Access Compliance Report

Public Rights-of-Way

(Curb Ramps)

Intersection ID: 14533	Main Street: S_TORRENCE_ST	Cross Street: S_KINGS_DR	Location: SE
ADA ID: 8E099995E63F	Ramp Type: Perpendicular Diagonal	Initial Pass/Fail: Fail	Overall Compliance: No
Severity Score: 50			
Codes/Mitigation Info/Possible Solution		Field Measurements/Component Compliance

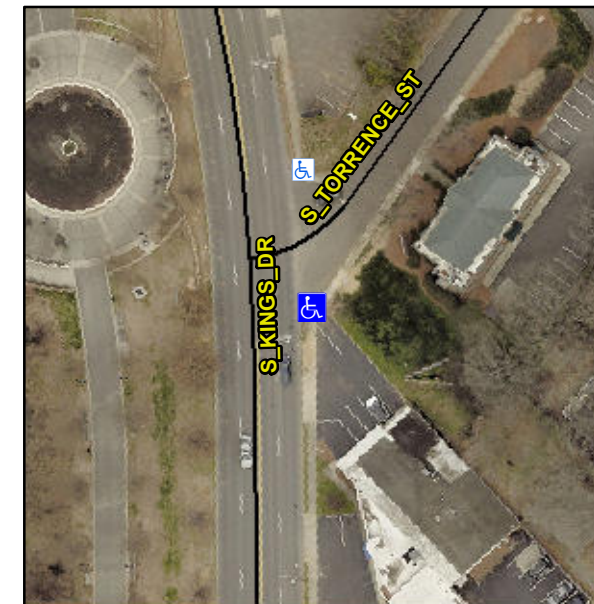
R304.2.2, R304.5.3

Compliance	Description	Data	Compliance	Description	Data
N/A	Ramp Length (in)	49.0	No	Ramp Slope (%)	13.2
Yes	Ramp Width (in)	48.0	No	Ramp XSlope (%)	7.9
N/A	Flare Type LT	N/A	N/A	Flare Type RT	N/A
N/A	Flare Slope LT (%)	N/A	N/A	Flare Slope RT (%)	N/A
N/A	Flare Traversable LT?	N/A	N/A	Flare Traversable RT?	N/A
N/A	Landing Length (in)	N/A	N/A	DWS Provided?	N/A
N/A	Landing Width (in)	N/A	N/A	DWS Contrast?	N/A
N/A	Landing Slope (%)	N/A	N/A	DWS Length (in)	N/A
N/A	Landing X Slope (%)	N/A	N/A	DWS Full Width?	N/A
N/A	Landing Curb? (Y/N)	N/A	N/A	DWS Offset (in)	N/A
N/A	Shared Landing?	N/A			
N/A	Gutter Ponding?	N/A	N/A	Gutter Slope (%)	N/A
N/A	Gutter Lip Ht (in)	N/A	N/A	Gutter X Slope (%)	N/A
N/A	Painted X Walk1?	No	N/A	Painted X Walk2?	No
	X Walk 1 Direction	To N		X Walk 2 Direction	To W
N/A	X Walk 1 Width (in)	N/A	N/A	X Walk 2 Width (in)	N/A
	X Walk 1 Slope (%)	2.2		X Walk 2 Slope (%)	0.9
	X Walk 1 X Slope (%)	2.1		X Walk 2 X Slope (%)	1.2

Remove & Replace Curb Ramp With Two New Directional Ramps or Equivalent.
